22 November 2021

Oakdale West Industrial Estate SSD 7348 – Modification Application 9

Figure 8: Amended Estate Masterplan (Source: SBA Architects)

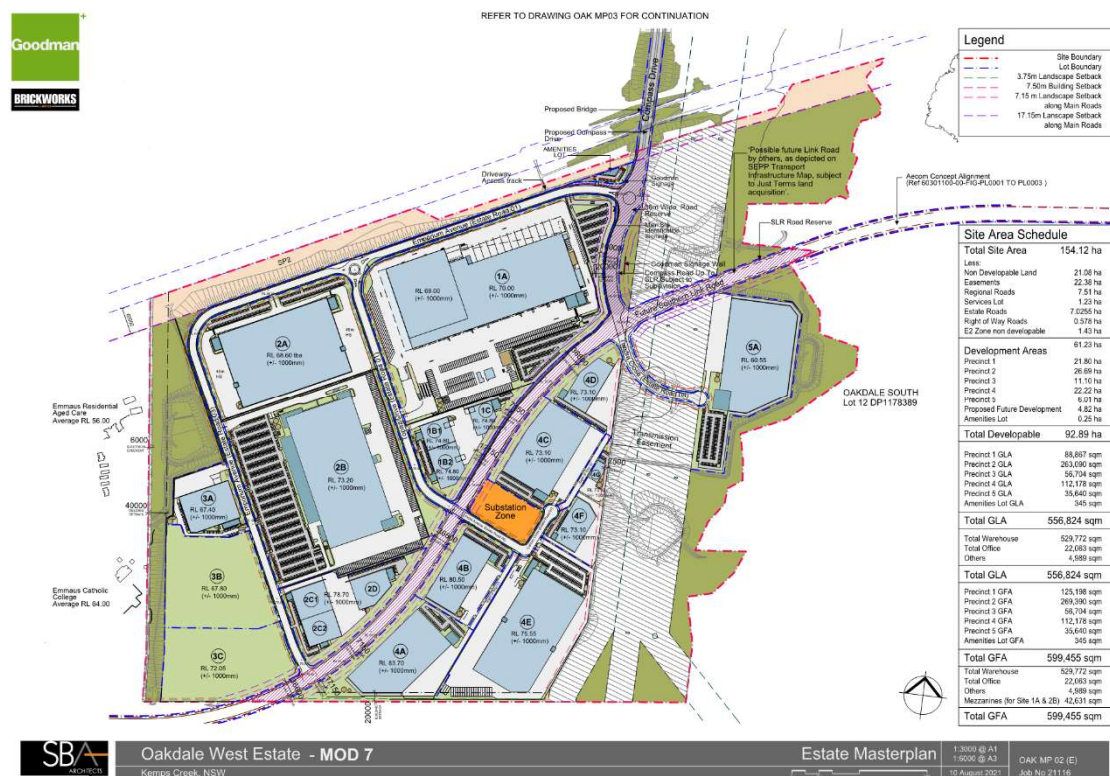
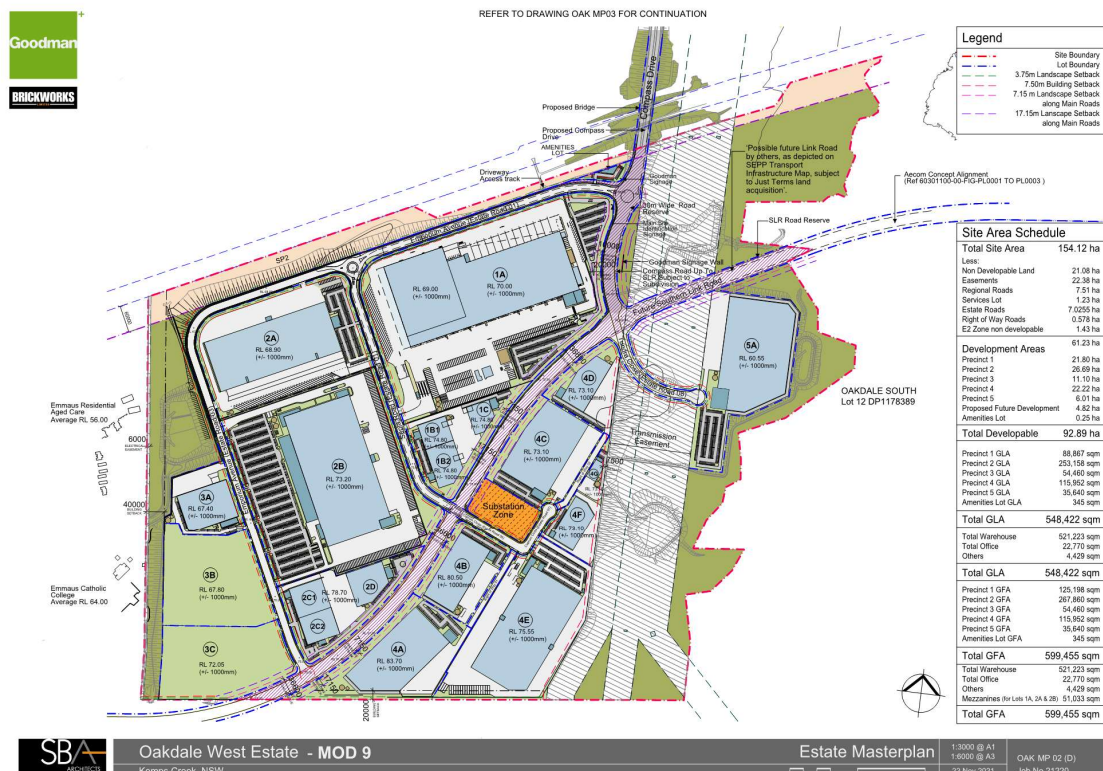
The proposed amendments to the layout of Lot 2A and Lots 2C and 2D associated with the amended Stage 3 SSD 9794683 application, discussed in Section 2.4, has led to a revision of the estate masterplan to reflect these changes, as shown in Figure 8.

Therefore, this application seeks a modification to the SSD 7348 consent to replace Figure 1 in Appendix 1 of SSD 7348 with the figure provided in Attachment 1.

Figure 4: Amended site layout – Building 2A (Source: SBA Architects)

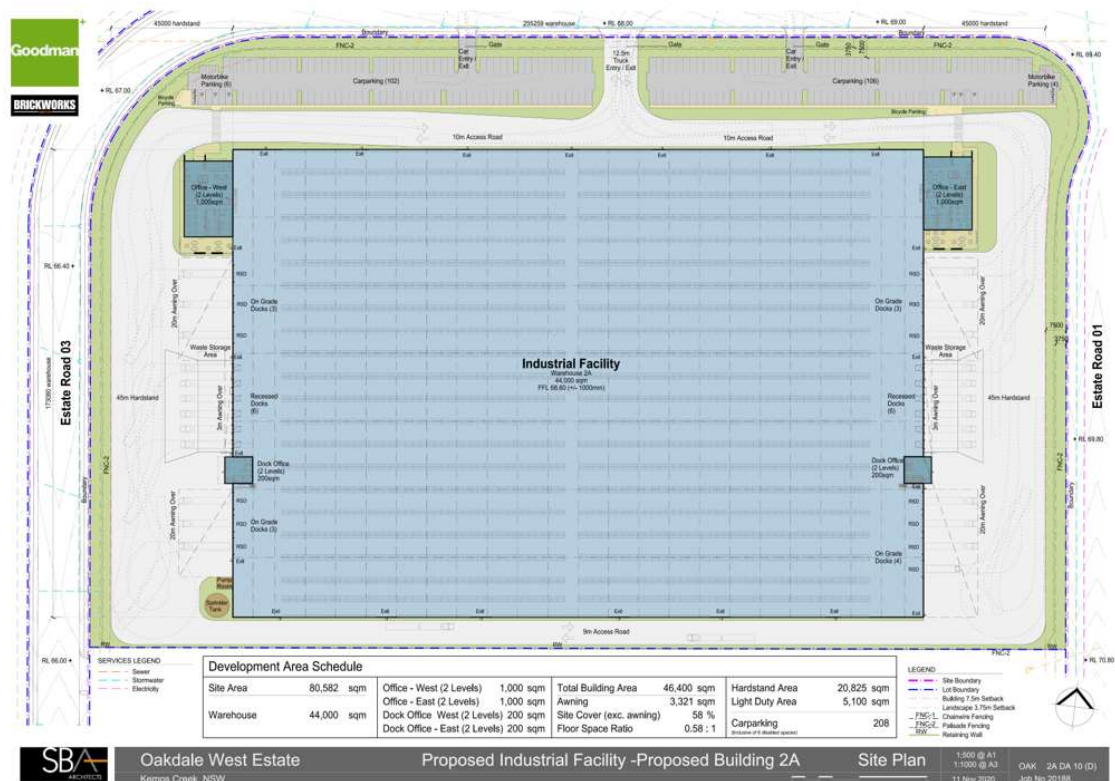
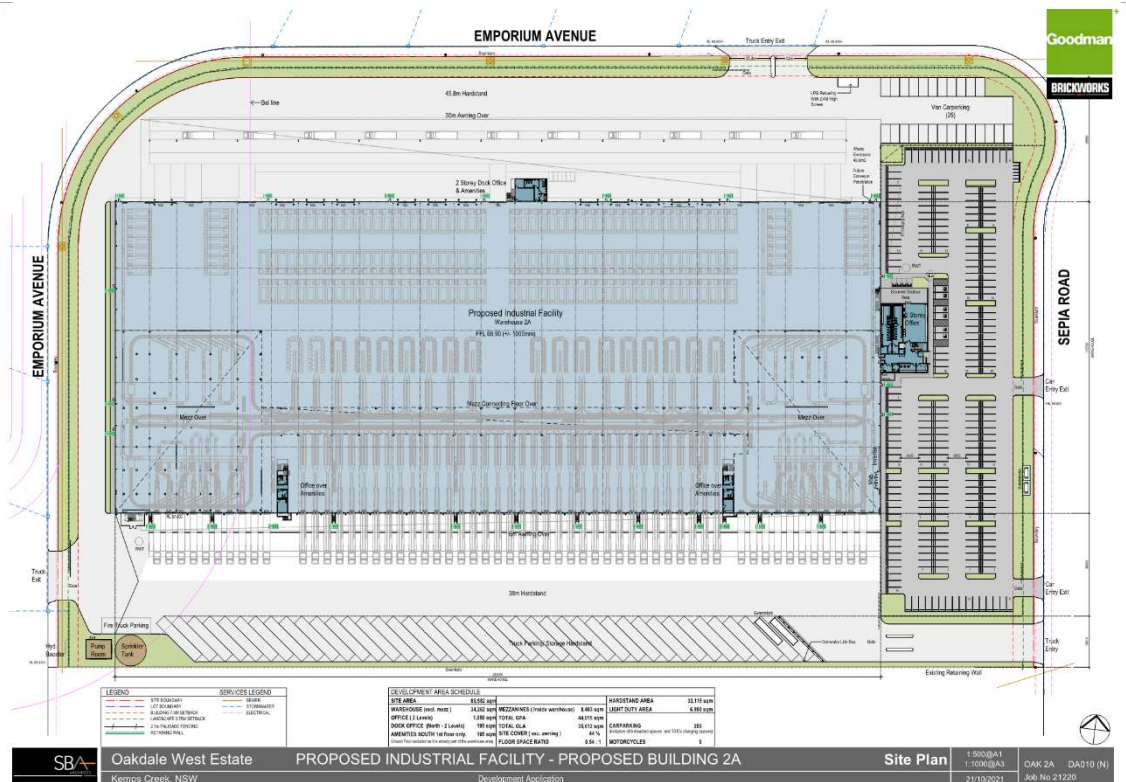
An amendment to the SSD 9794683 application was submitted on 25 October 2021 which made changes to the layout of Building 2A and the configuration of driveway access to Building 2D.

The proposed layout changes to Building 2A include changes to warehouse and office layout, access changes and internal fitout.

Figure 5: Amended site layout – Buildings 2C and 2D (Source: SBA Architects)

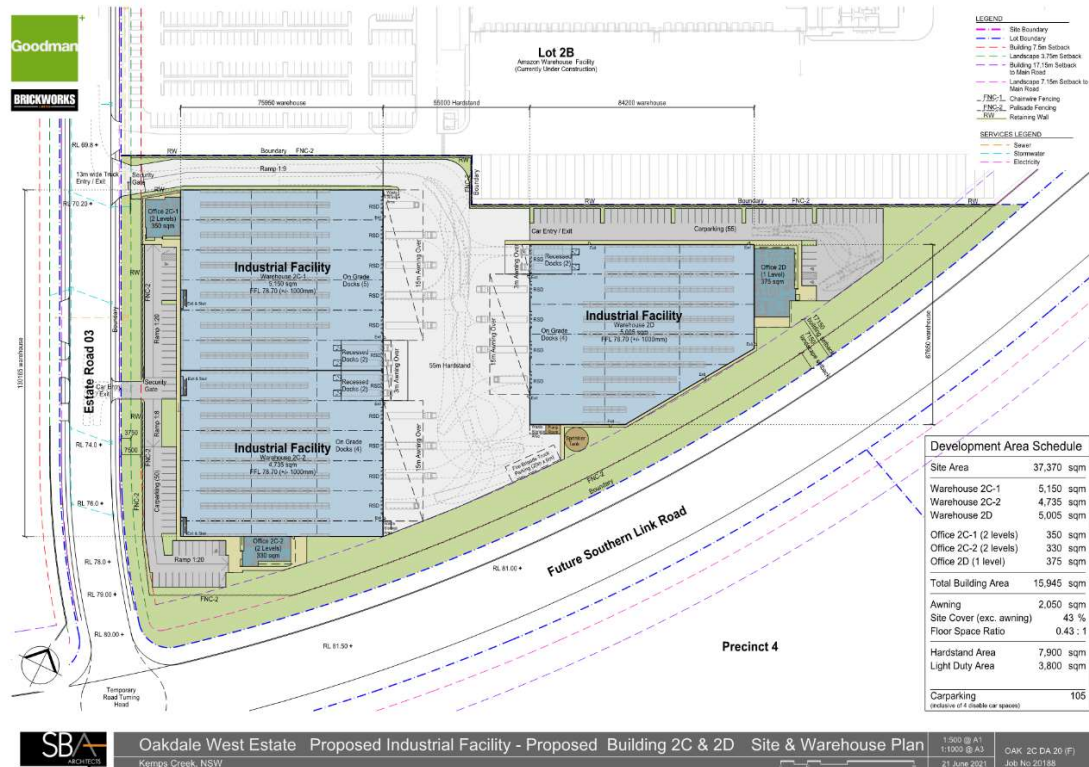
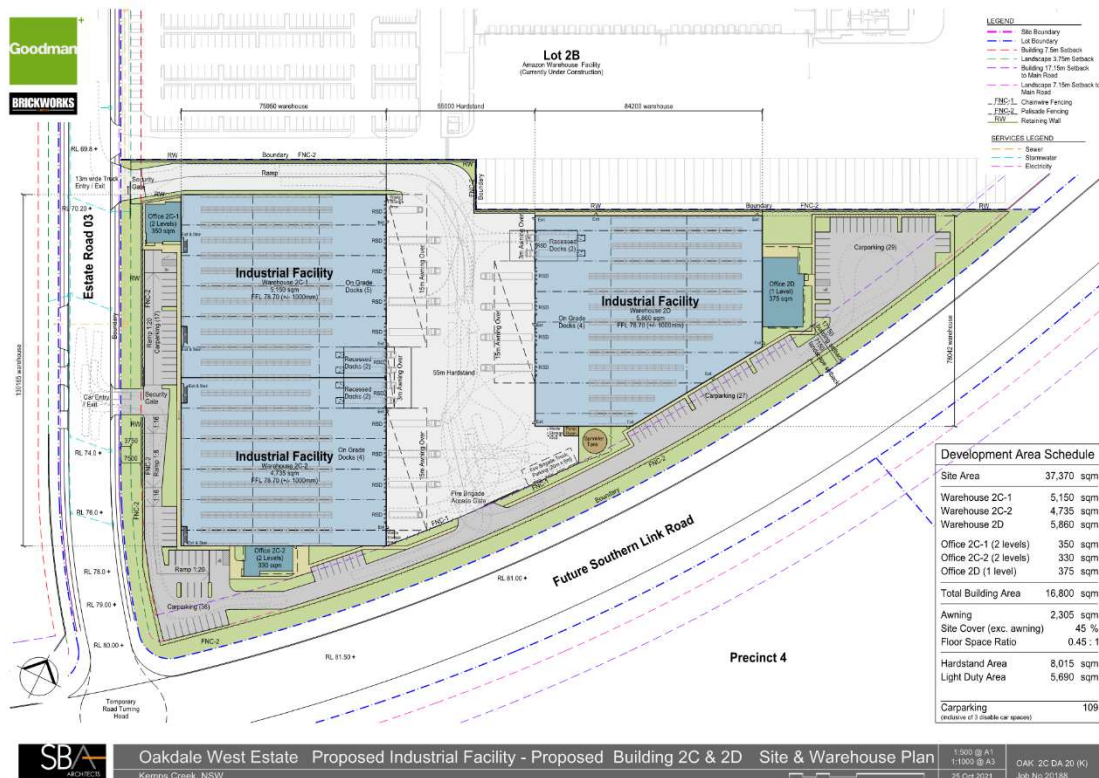
The proposed changes to Buildings 2C and 2D relate to access arrangement for Building 2D to provide a dedicated and separate heavy vehicle access driveway to the warehouse loading docks.

Figure 7: Warehouse 2C Elevations (Source: SBA Architects)

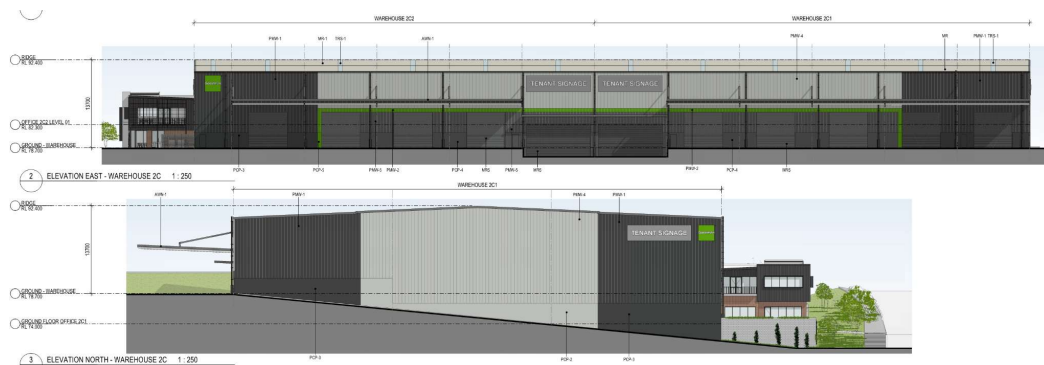
The Department notes that the effective height of Building 2C is approximately 22.2 m, which exceeds the 15 m limit in the Oakdale West Estate Development Control Plan (OWEDCP).

The “effective building height” of Building 2C is a consequence of the profile of the estate landforms, which includes an approximately 10 m fall in Estate Road 3 from the south to the north, and the establishment of level pad for the warehouse buildings and loading docks (Figure 6 and Figure 7).

The Applicant seeks to amend the existing height limits in Condition B10 of SSD 7348 for Building 2C, to a maximum ridge height of 22.2 m as measured from the driveway entry point. This application also seeks to exclude Building 2C from the 13.7 m height limit in Condition B11, to reflect the modified height limit in Condition B10.
